## Service Information Bulletin

SUBJECT	DATE
TCM SPN 520999 FMI 7	March 2016

Publication Number / Title	Platform	Section Title	Change
DDC-SVC-MAN-0140	DT12	SPN 520999/FMI 7	Update to Step 6
DDC-SVC-MAN-0084	DT12	SPN 520999/FMI 7	
DDC-SVC-MAN-S084	DT12	SPN 520999/FMI 7

d500248

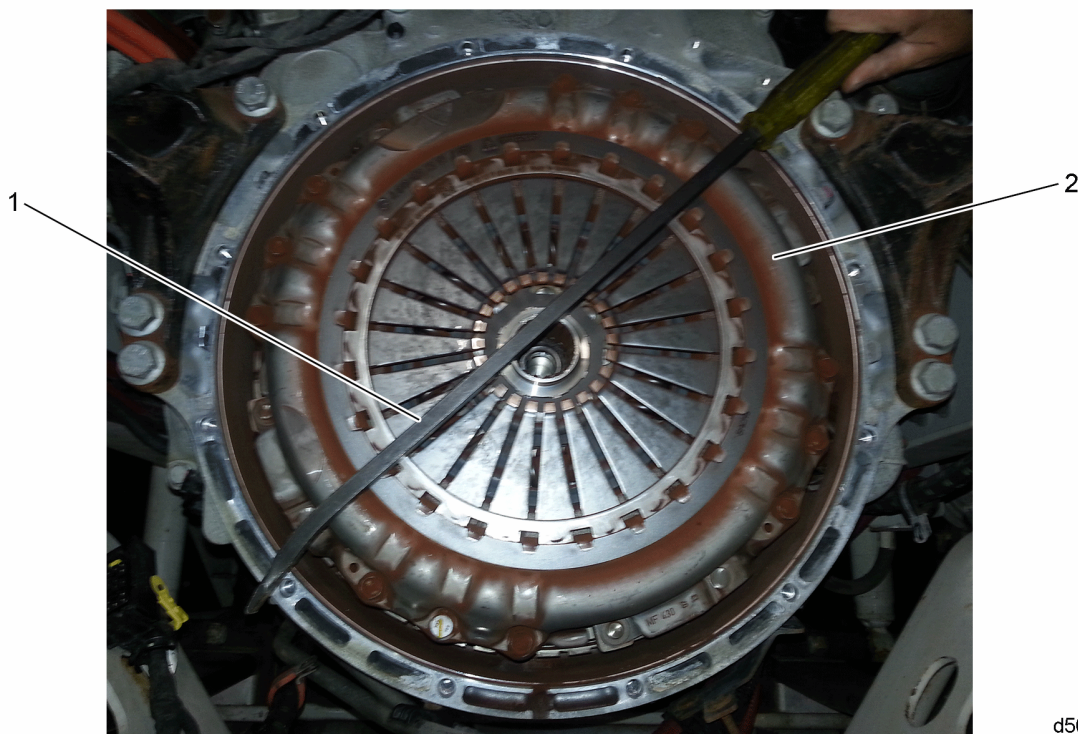
2. Start the engine and idle for two minutes.
3. Is the transmission air supply pressure greater than (689 kPa)100 psi?
  - a. Yes; Go to step 6.
  - b. No; Go to step 4.
4. Turn the ignition OFF.
5. Inspect transmission air supply lines and fitting for leaks. Repair as necessary; repeat all steps in this procedure.
6. Under the Actions menu, select transmission heading and then choose Clutch Apply Leak Test; execute routine. Does the result indicate a successful completion, test pass? Note that test may have to be performed three times in order to get a "pass" result.
  - a. Yes; Go to step 7.
  - b. No; Go to step 8.
7. Under Instrumentation tab, select Transmission Learned Values. Is instrument Learned Value Clutch Minimum greater than 33 mm or Clutch Limit Stop Maximum Value greater than 51 mm?
